SUBJECT: Receive staff report on revisions to the shoulder paving policy

DRAFT MEMORANDUM

Date: September 8th, 2016
To: Susanna Chan, PE
From: Franz Haidinger, PE; Marcy Kamerath, CPSWQ, QSD/QSP
Subject: Los Altos Shoulder Paving Policy (Standard Detail SU-20, May 2010)

Figure 1 - Asphalt used in shoulder parking and drainage swale area (NCE)

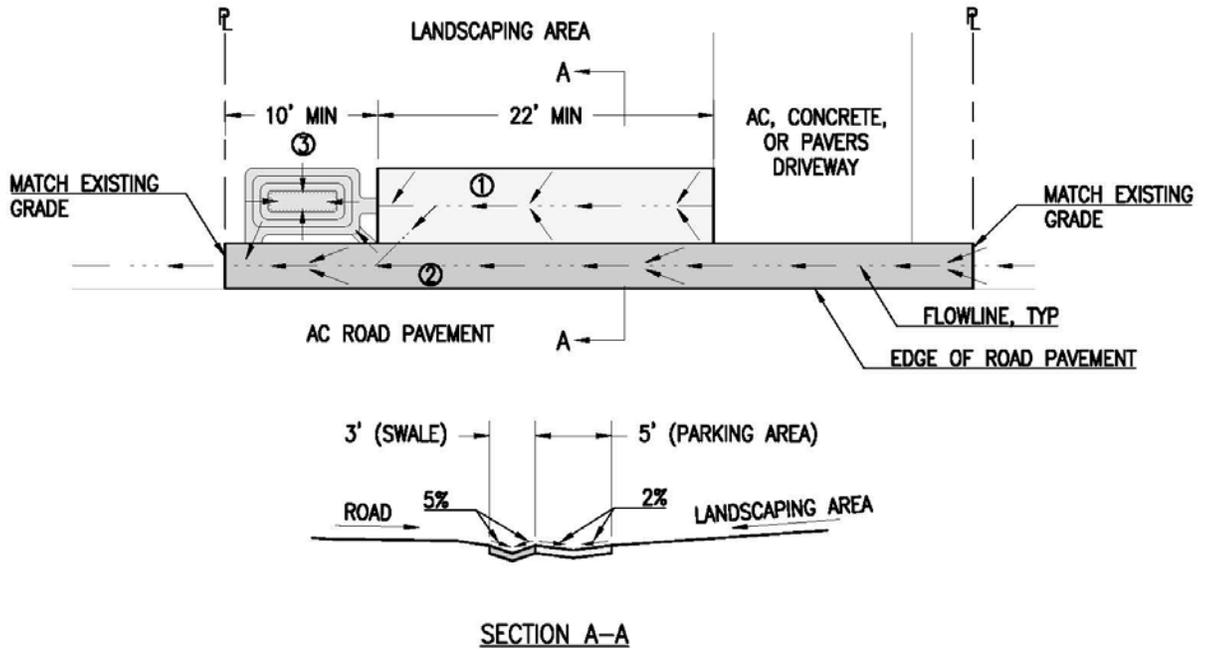
One prominent concern observed during the site visit is that misinterpretation of the Policy appears to result in AC being used in the shoulder parking area which creates a visual widening of the street (**Figure 1**). In some cases this increased the previous pavement width by up to 30%. Clarifying the Policy to specify which materials are suitable for use in the drainage area and shoulder parking area could improve implementation of the Policy and help address concerns related to aesthetics. In addition, the City recently improved its plan inspection and review procedures for implementation of the shoulder paving Policy which should help to minimize misinterpretation of the Policy.

Figure 6 - Various patterns for installation of permeable concrete pavers (Interlocking Concrete Pavement Institute, 2004)

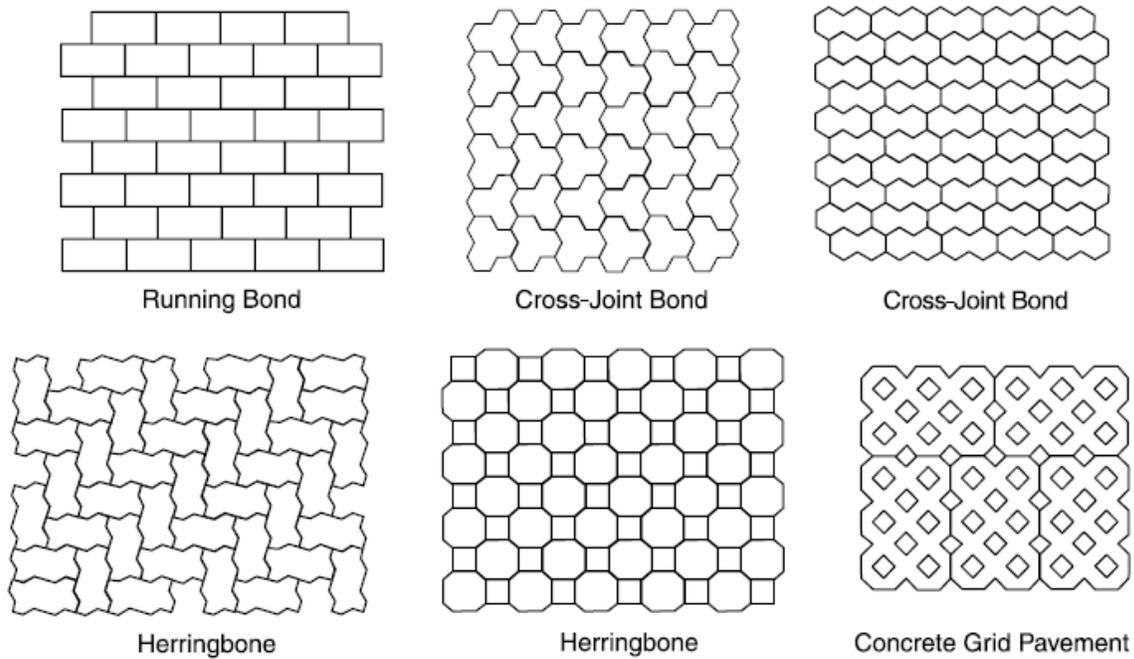
Rationale: **Table 1** summarizes other alternative permeable materials for use in lieu of AC in the drainage swale (AC is included in the table for comparison). Based on a qualitative review, pervious concrete pavers are proposed for use in the drainage swale. While several alternative materials could be used, pervious concrete pavers are suggested because they are more consistent with a rural aesthetic compared to porous AC or pervious concrete. Pervious concrete pavers provide an opportunity to infiltrate stormwater, and can be installed forming a swale to allow positive drainage of excess runoff through a swale (**Figure 4**). In addition, pervious concrete pavers are available in multiple color, texture, and patterns which the City can further specify to meet a desired aesthetic (**Figures 4, 5, and 6**).

Figure 7 - Cross section showing vertical barrier between pervious pavement and existing road (Caltrans Pervious Pavement Design Guidance, 2014)

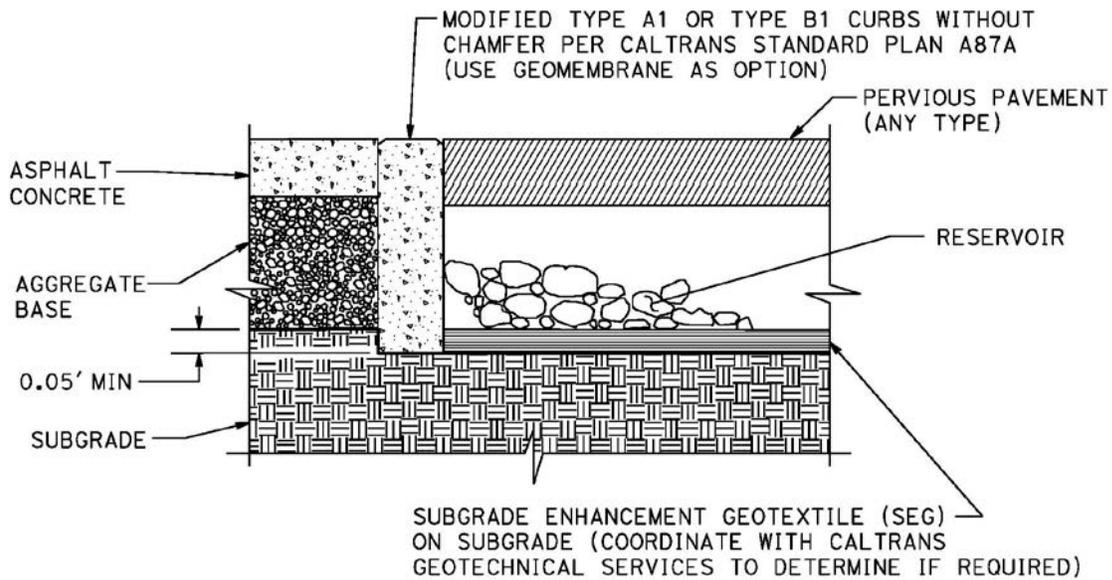
- Costs can be substantially higher than conventional pavement
- Installation will require excavation into the subgrade to create storage for stormwater runoff and to match existing grades at the property line
- A vertical barrier must be installed around the perimeter of the permeable pavers to protect the roadway to confine the pavers (**Figure 7**)
- Where utility conflicts exist or other factors occur which prohibit use of pervious concrete pavers, an alternative could be stabilized decomposed granite which would limit the amount of material that migrates into the road and storm drain system
- Maintenance requirements can vary depending on the type of permeable concrete paver used. Material with smaller pore sizes may require specialized vacuum truck

Figure 3 - Recommended revisions to the Policy

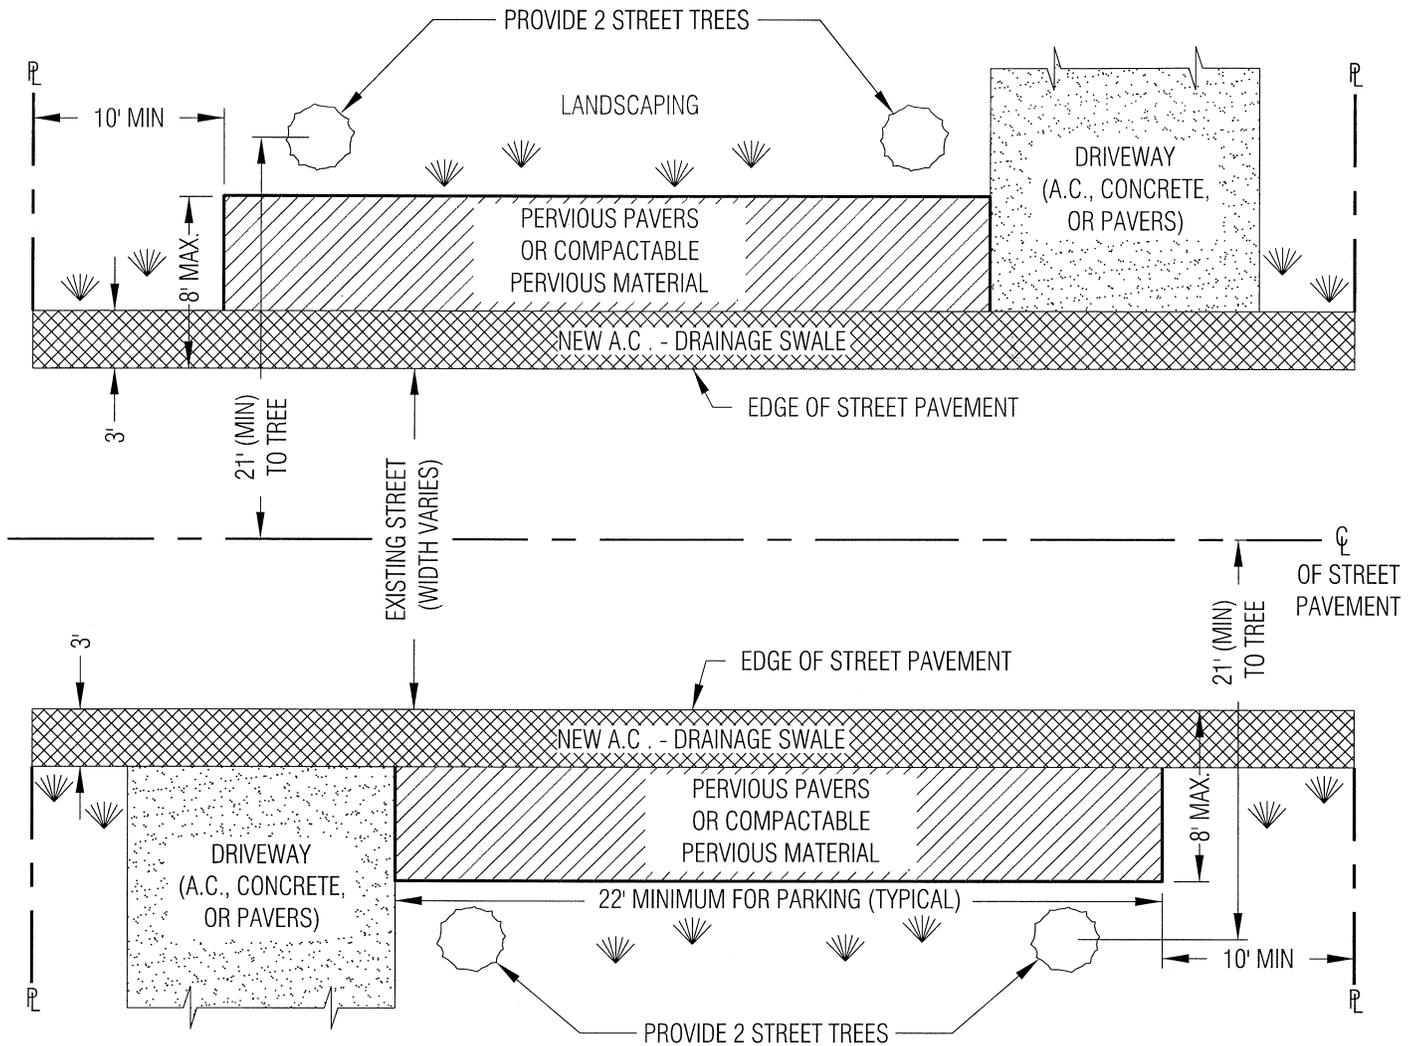
Based on known public concerns with the Policy, site visit observations, consultation with the City and Subcommittee, and NCE's qualitative assessment of alternative pavements, NCE developed recommended revisions which are illustrated in Figure 3 and discussed in detail below.

Clarifications which could improve the Policy are included in **Figure 3** and include the following:

- Flow routing – Flow paths are presented in Figure 3 to provide clarification and guide contractors implementing the shoulder improvements. Constructing improvements consistent with the illustrated flow paths will promote positive drainage through the swale, allow the shoulder parking area to receive and capture some runoff, and route excess flows to the drainage swale.

- Specify slopes for drainage swale and shoulder parking area – A typical cross section specifies a 5% slope for the drainage swale to promote positive drainage away from the roadway. A 2% slope is specified for the parking area to promote positive drainage to landscaped areas where they are installed downgradient from the parking area, and/or to convey excess flows which do not infiltrate into the shoulder parking area into the drainage swale.

- Match existing grades – To reduce drainage issues associated with planned improvements, the Policy should specify that the up and downstream limit of improvements must match existing grade.

- ① PARKING AREA: PERVIOUS CONCRETE PAVERS, DECOMPOSED GRANITE, GRAVEL (CRUSHED STONE 1" MAX), GRASS BLOCKS, GRAVEL BLOCKS.
- ② DRAINAGE SWALE: PERVIOUS CONCRETE PAVERS, COLOR AS DETERMINED BY CITY.
- ③ OPTIONAL: BIOSWALE/RAIN GARDEN IN LANDSCAPE AREA IF FEASIBLE TO RECEIVE RUN-OFF FROM SWALE/PARKING AREA. DESIGN BY ARCHITECT OR ENGINEER.
